**MCPB**  
**Item # 3**  
**July 13, 2006**

**REVIEW TYPE:** Preliminary Plan Review

**PROJECT NAME:** Downtown Silver Spring

**CASE #:** 11998107B

Attachment "A"

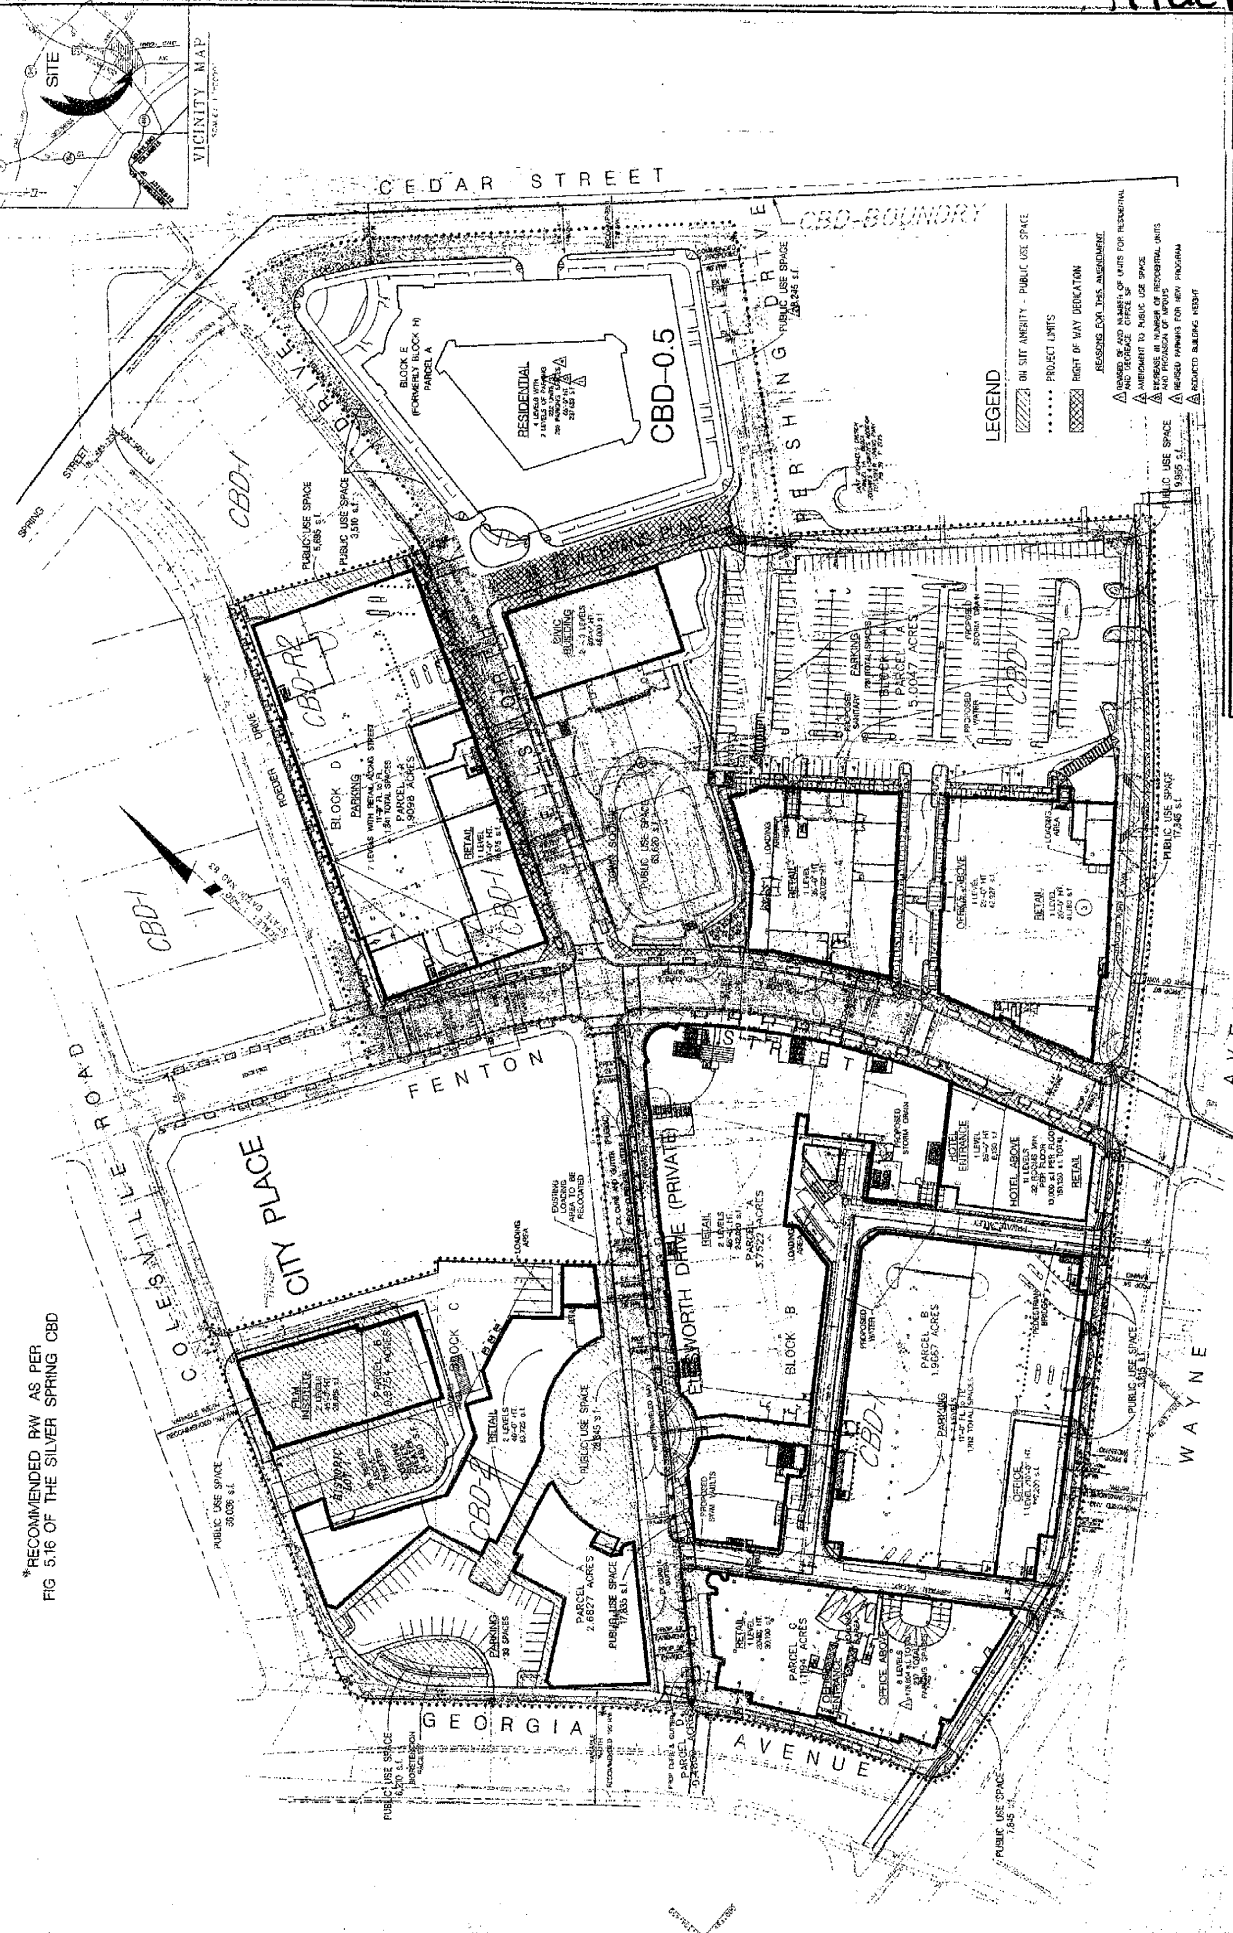
We have completed our review of the preliminary plan dated 1/3/06. This plan was reviewed by the Development Review Committee at its meeting on 2/27/06. We recommend approval of the plan subject to the following comments:

2. Show all existing planimetric and topographic details specifically paving, storm drainage inlets, driveways adjacent and opposite the site, sidewalks and/or bikeways on the preliminary plan.

3. We are in receipt of the applicant's request for truncation waiver and are not able to support approval at this time. The truncation exhibit should clearly demonstrate that the right-of-way proposed behind the curb will be adequate for the anticipated movements of pedestrians and bicyclists as well as accommodate all existing and proposed public amenities (such as sidewalks, handicap ramps, bus stop facilities, streetscaping, traffic signal poles and related facilities, etc.) and utilities. Exhibits "C" and "D" clearly lack that. Also coordinate with all utility companies to make sure that all existing and proposed public utilities have been shown on the all exhibits correctly and completely.

4. The sight distances study has not been accepted. Prior to approval of the record plat by DPS, the applicant's engineer will need to submit a revised sight distances certification. The revised form will need to reflect minimum of three hundred and twenty five (325) feet of sight distance in each direction for the exit onto Cedar Street.

**STAFF RECOMMENDATION:** Approve revision to the previous conditions of approval, pursuant to Chapter 50 of the Montgomery County Subdivision Regulations, as follows and with the following conditions:

- 1) Total development under the subject preliminary plan is limited to 222 residential units, including a minimum 12.5% moderately priced dwelling units (MPDUs), 507,340 square feet of retail, 228,931 square feet of office, 48,000 square feet of civic building, and a hotel with 242 rooms.

- 2) The applicant shall dedicate and show on a new record plat rounded truncations for the corners of Veteran's Place and Pershing Drive, Veteran's Place and Ellsworth Drive and Cedar Street and Pershing Drive, in accordance with the comment letter from the Department of Public Works and Transportation (DPWT) dated May 26, 2006.

- 3) The Applicant shall construct the proposed driveway entrance on Cedar Street to prohibit outbound left turns from the site, consistent with the DPWT letter dated May 26, 2006.
